From: Oswald, Hank
Sent: Thursday, June 04, 2015 10:41 AM
To: 'Robertbaxter27@aol.com'
Subject: RE: LIANG Feasibility Plan 16035 Carr's Mill Road
Attachments: GIS_16035 Carrs Mill Road.pdf

FULLER RESIDENCE
16035 CARRS MILL ROAD

From: Oswald, Hank
Sent: Monday, April 27, 2015 11:19 AM
To: 'Liangguizhi@yahoo.com'
Subject: Perc Plan Review Comments_16035 Carrs Mill road

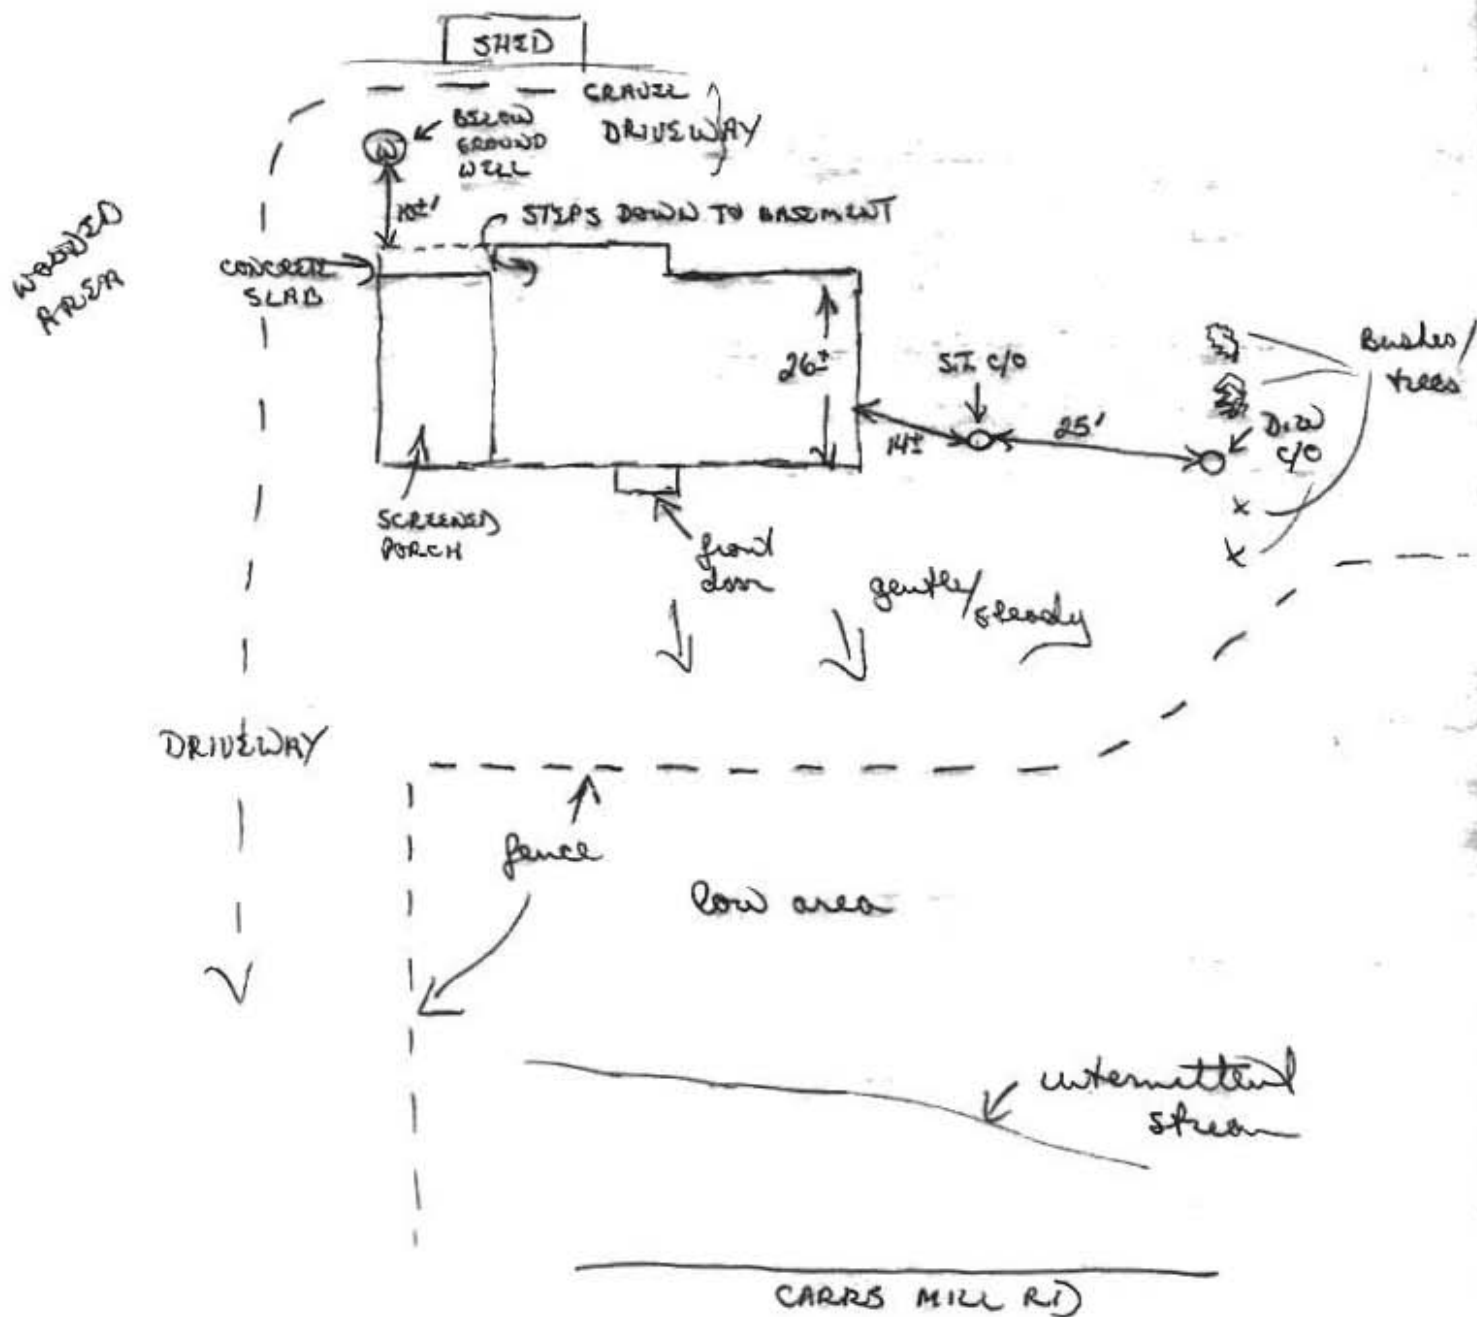
- Showing the existing tile field won't be an issue.
- The Do Not Test Co soil unit boundary is not at the flood plain line. The Co soil line retains right around the 495 contour and up to the 500 contour line on the north property boundary (See attached GIS image). Please show this line and then stay 25' off of that. In addition, show the soil unit boundaries as they are represented on the official USDA soil survey.
- The SDA must also be 25' from the steep slopes on the lower side as well as the upper side.
- The well area on lot 1 is down gradient of the septic area, but far less than 200' away.

Assuming the setbacks have been met and the scale is correct, it looks to be okay. Please show the existing drain field on Lot #1?

Per our conversation yesterday, attached is an updated Percolation Test Plan pdf per your comments dated April 27th, 2015.

Also, we plan to revise the stake out per the latest plan. We placed the 1,500 sq. ft. Well Boxes within the Floodplain limits per our conversation as well.
